Piper Aircraft Corporation

November 12, 1973

Subject: Flux Sensor Caution Placard Installation

PA-23-250 (Six Place) Aztec 27-4053, 27-4574 to 27-7405278 incl.

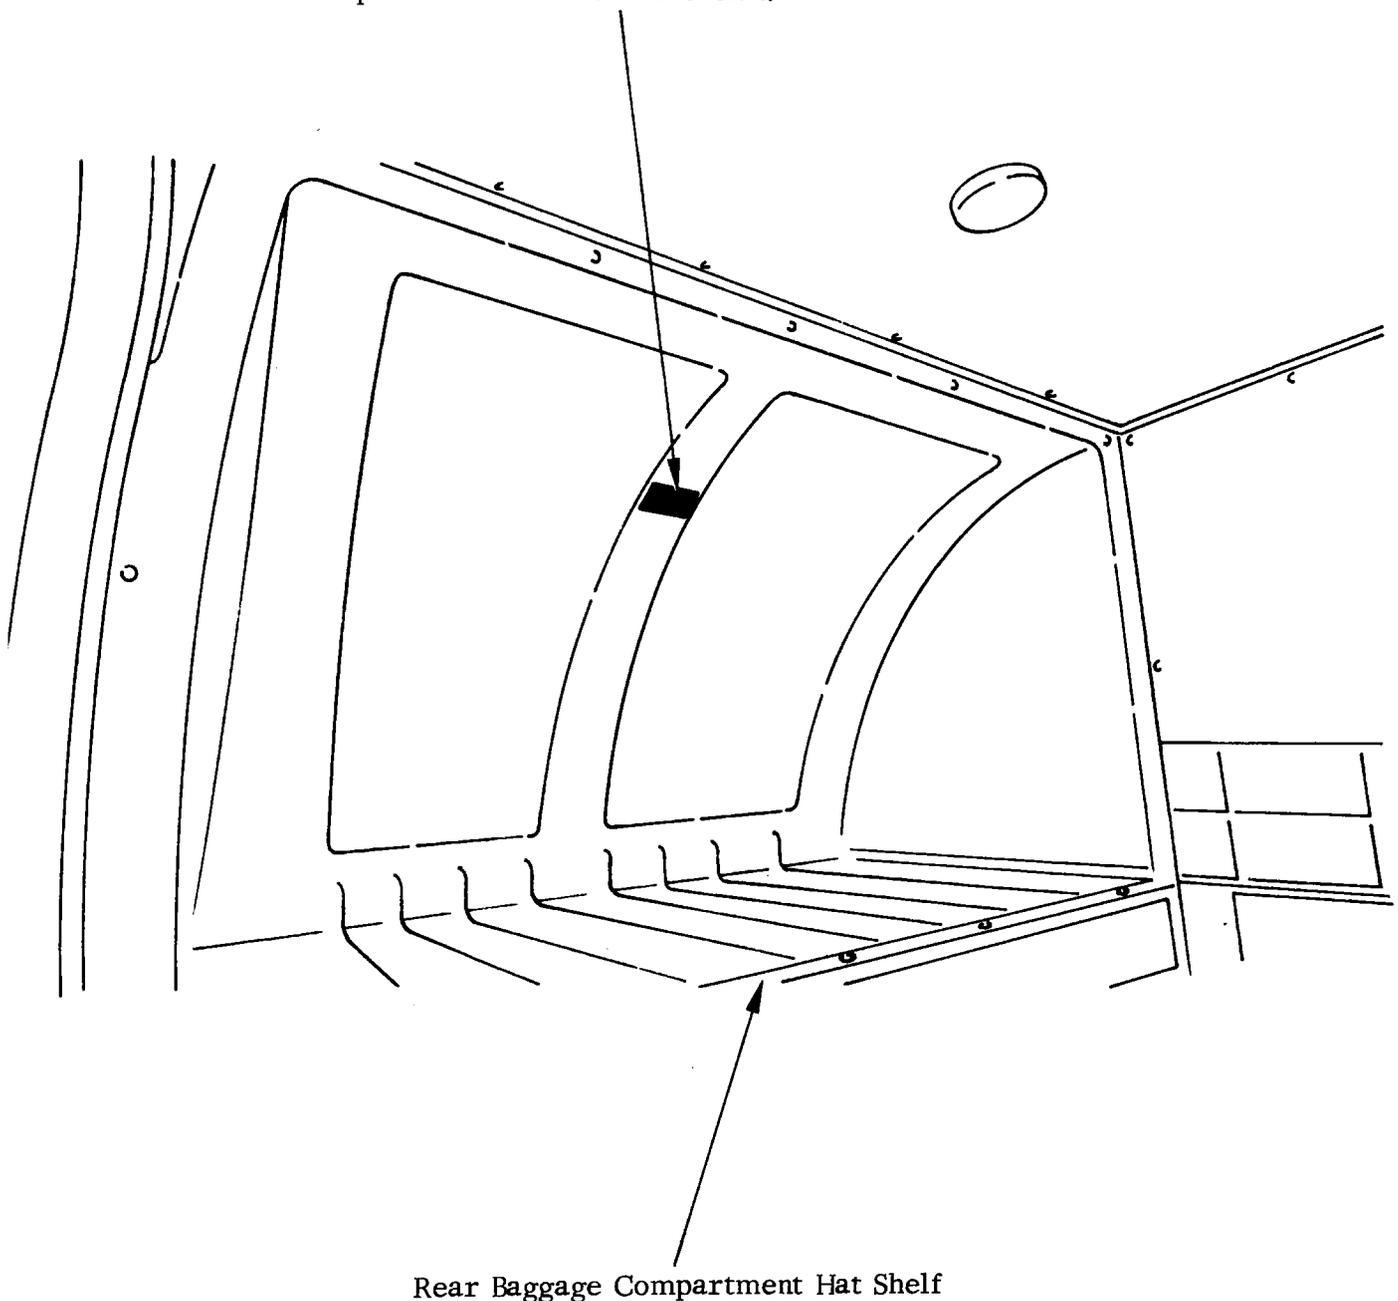
Purpose: On aircraft referenced above with the AltiMatic V F/D or AltiMatic V F/D-1 Automatic Flight Control System installed, the flux sensor (which functions as a magnetic compass in the flight director system) is located aft of the rear baggage compartment hat shelf. It has been reported that storage of metallic objects on the rear baggage compartment hat shelf may interfere with proper flux sensor function.

This service release provides material and instructions to install a caution placard on the raised portion of the hat shelf, as depicted on the sketch on the reverse side of this service release. This placard cautions against storage of metallic objects on the rear baggage compartment hat shelf.

1. Install Placard, Piper Part No. 33564-00, on raised portion of the hat shelf as shown on the sketch on the reverse side of this service release.

Install Placard, P/N 33564-00, on raised portion of hat shelf as shown.
